Access Compliance Report Public Rights-of-Way (Curb Ramps)

Main Street: N/A Cross Street: OSO_PKWY Location: NW

ADA ID: RPRK211021120506 Ramp Type: Type 1 - Perpendicular Initial Pass/Fail: Pass Overall Compliance: No Severity Score: 5

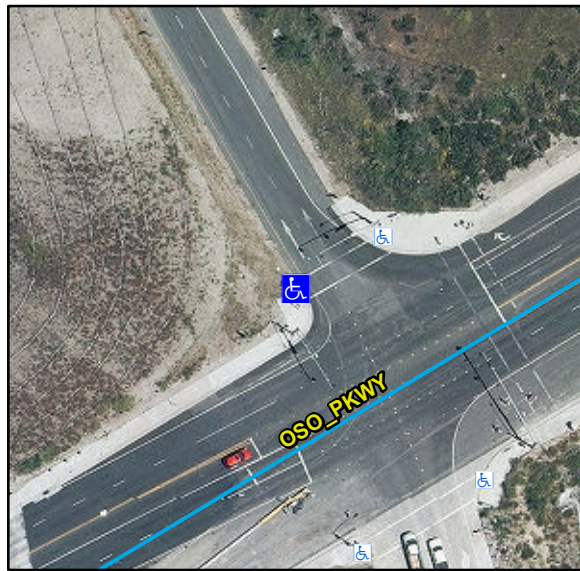
Remove & Replace Curb Slope. Remove & Replace Gutter.

R304.2.2, R304.5.4, STD 1115
